SERVICE INFORMATION LETTER MD-80/90 SERIES

**PASSENGER ADDRESS SERVICE INTERPHONE CALL SYSTEM (PASICS),
ELECTRONIC SWITCHING UNIT (ESU) P/N 686-3000-003, used on board the
MD-80/90 series aircraft**

Distorted or choppy PA audio when using the cockpit aft pedestal handset.

**SIL98-2
Nov. 18, 1998
Page 1**

A3 Trim Board Location

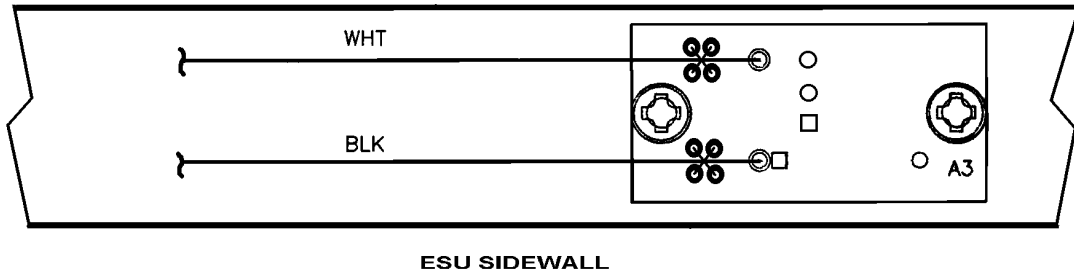
**Possible miswire (reversal) of two wires attached to the Trim Board (A3) in ESU P/N
686-3000-003 serial numbers 0902 thru 0954.**

If operator has test fixture to verify operation of unit, test per SB686-3000-23-3 Rev.1, page 7, test step *L. Audio Test – Pilot PA Audio*, subtest (6). If distortion is evident at A3R1 maximum setting, remove unit cover and inspect position of white and black wires attached to A3 Trim board mounted on side wall of ESU. The white wire should be attached to the A3 board eyelet towards the top and the black in an eyelet towards the bottom, as shown below. If reversed, remove A3 board from sidewall and correct position of the wires, then retest unit.

**Return suspected unit to address below for correction of problem at no charge.
Reference this SIL in return paperwork.**
